**City of Pembroke Pines**  
**Planning & Economic Development Department**  
**601 City Center Way 3<sup>rd</sup> Floor**  
**Pembroke Pines FL, 33025**

<b>Agenda Date:</b>	September 11, 2025	<b>Application ID:</b>	SP2025-0001
<b>Project:</b>	Chabad of Pembroke Pines Mikveh	<b>Project Number:</b>	PRJ2025-0002
<b>Project Planner</b>	Cole Williams, Senior Planner		
<b>Owner:</b>	Chabad Lubavitch of Pembroke Pines INC	<b>Agent:</b>	Jeremy Shir
<b>Location:</b>	18490 Johnson Street	<b>Commission District</b>	4
<b>Existing Zoning:</b>	PUD (Planned Unit Development)	<b>Existing Land Use:</b>	Commercial
<b>Reference Applications:</b>	SUBDR2025-0001, ZV2025-0010		
<b>Applicant Request:</b>	Construct a free-standing Mikveh.		
<b>Staff Recommendation:</b>	Approval subject to the recordation of the underlying plat		
<b>Final:</b>	<input checked="" type="checkbox"/> Planning & Zoning Board <input type="checkbox"/> City Commission		
<b>Reviewed for the Agenda:</b>	Director:  Assistant Director:

Jeremy Shir, agent, requests approval to construct a free-standing Mikveh with associated site, signage, lighting and landscape modifications for the Chabad of Pembroke Pines located at 18490 Johnson

WATER & SEWER PLAN  
FOR  
**PROPOSED MIKVEH AT**  
CHABAD OF PEMBROKE PINES  
18490 JOHNSON STREET, PEMBROKE PINES, FL

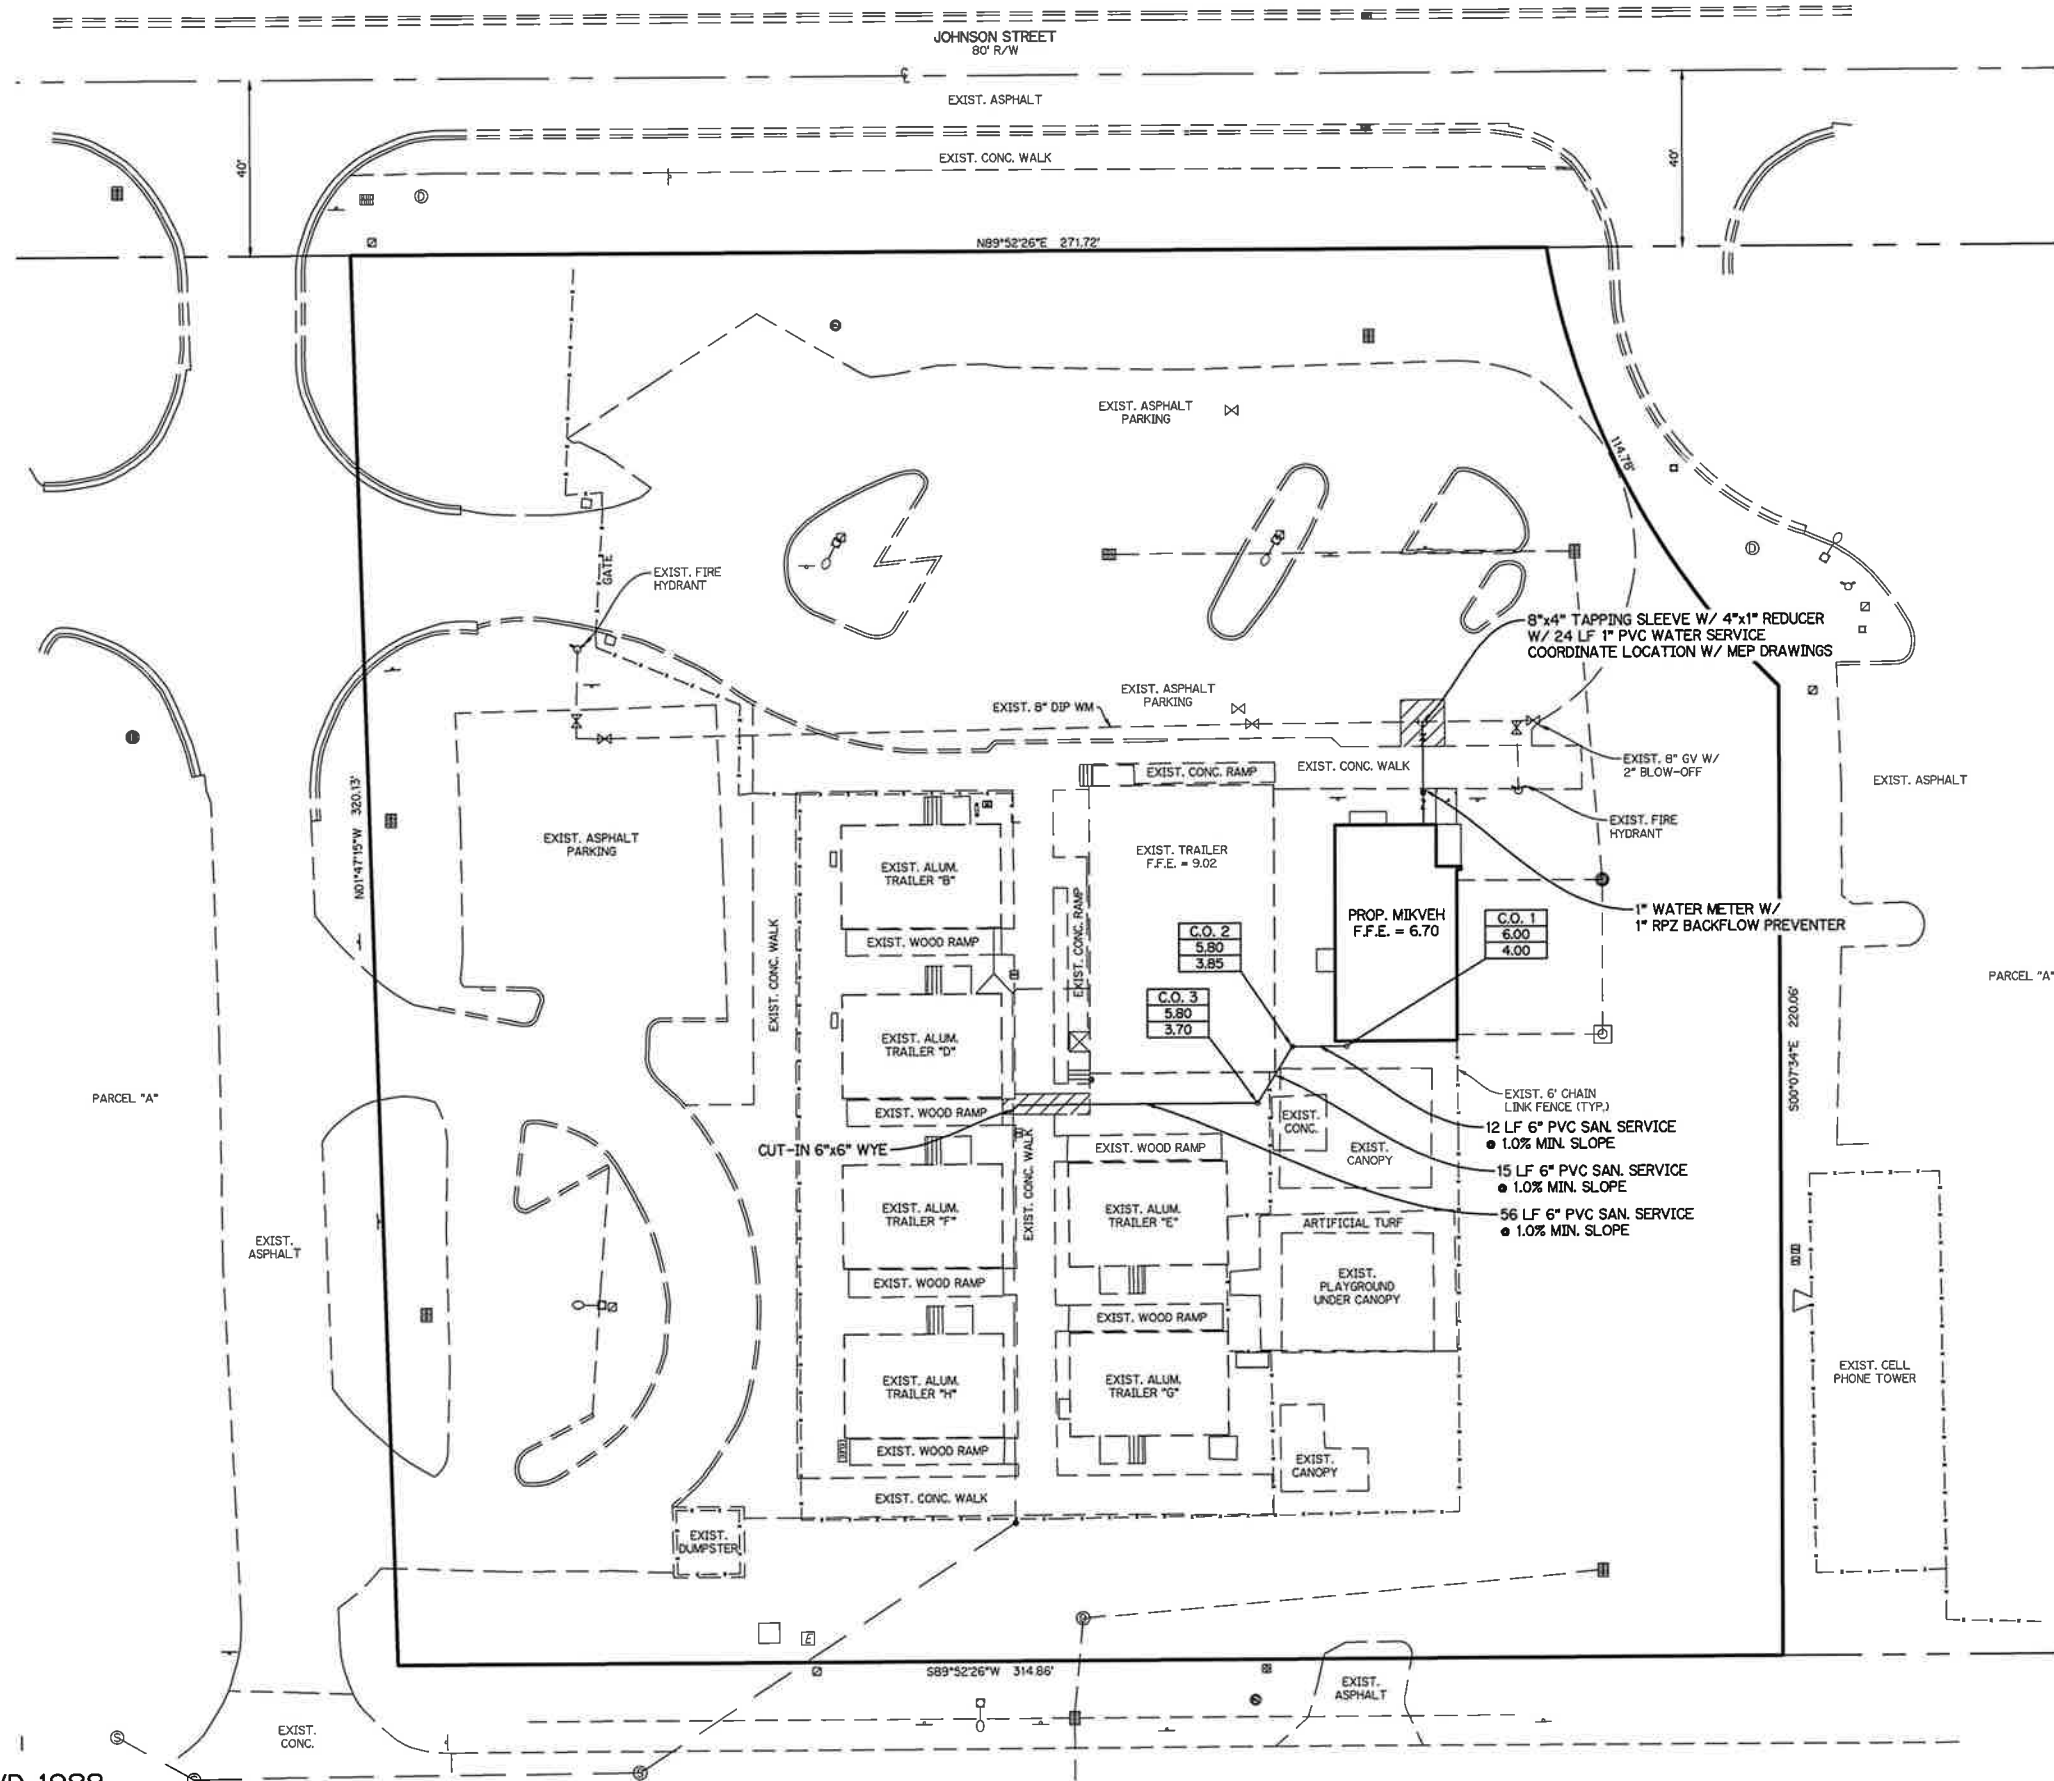
20. The existing utilities depicted on the plans do not match the legend, it is difficult to distinguish between the proposed and existing utilities. Grey out the existing utilities and only keep the proposed utilities in black.

21. There is a meter box on the north side of Trailer B based on the land title survey provided, therefore a new meter box must be placed for the proposed water service line for the proposed building. Reference service water later City Detail W-4 for water meter requirements. Add detail to set.

22. The proposed water service line calls for a 2"x 2" tee with a 2" PVC line coming out an 8" existing DIP water main, which is not possible. You need an 8" x 8" or 8" x 6" or 8" x 4" tee with a reducer to a 2" line. Note that a 1" line is called out per Pembroke Pines City Detail W-4. Add detail to set.

25. Sanitary cleanouts in unpaved areas are required to have concrete collars per City Detail S-10, add detail to set.
26. The proposed sanitary laterals going through existing concrete on the west side of the sheet. Call out concrete to be demolished in the demolition sheet and call out concrete to be replaced in the grading and drainage plan. Reference City Detail R-28 for concrete requirements.
